Board identification

This errata sheet applies to the first batch of the STEVAL-CTM012V1 evaluation board. The batch is identified by lot 4821 and the resistors shown in Figure 2.

The STEVAL-CTM012V1 is a high efficiency 250 W compressor solution based on STSPIN32F0601Q and STD8N60DM2.

Figure 1. STEVAL-CTM012V1 evaluation board lot 4821 - bottom detail

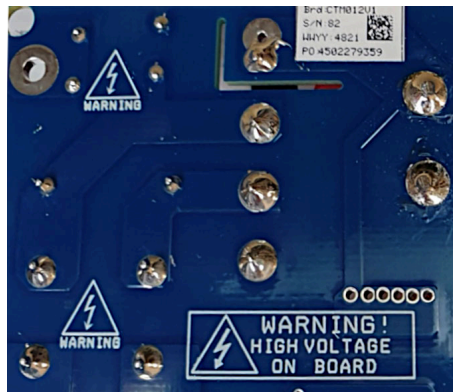
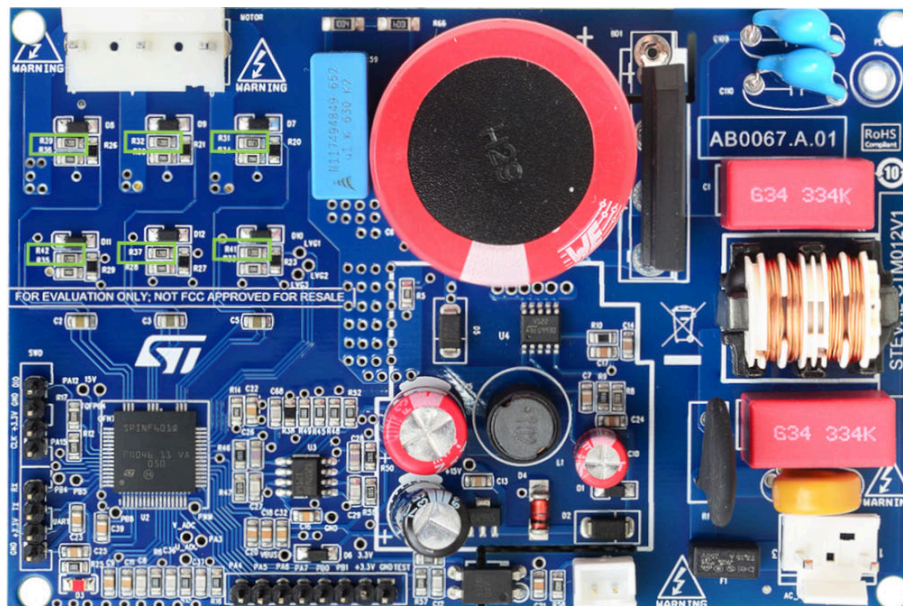
Important: Not the entire lot 4821 is impacted. Refer to the figures below to check whether your board is impacted.

Figure 2. STEVAL-CTM012V1 evaluation board lot 4821 - resistor detail

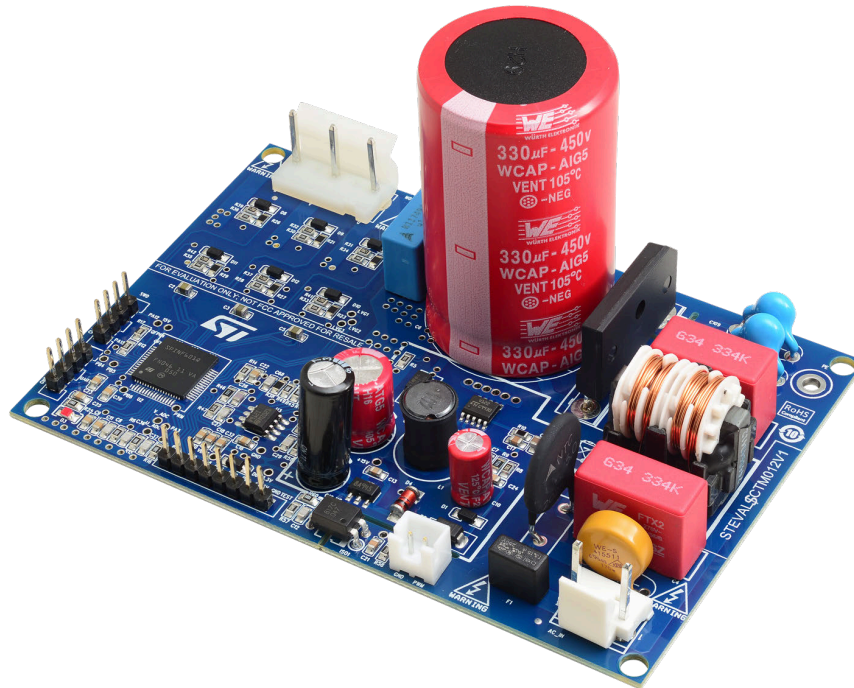
The STEVAL-CTM012V1 first batch (lot 4821) mounts the R31, R32, R37, R39, R41, and R42 resistors with a current resistance value of 120 ohm.

This lot works properly under normal or standard load conditions. However, if used under no-load conditions, that is without a connected motor, it might not work properly.

Replace the R31, R32, R37, R39, R41, and R42 resistors with 10-ohm resistors.
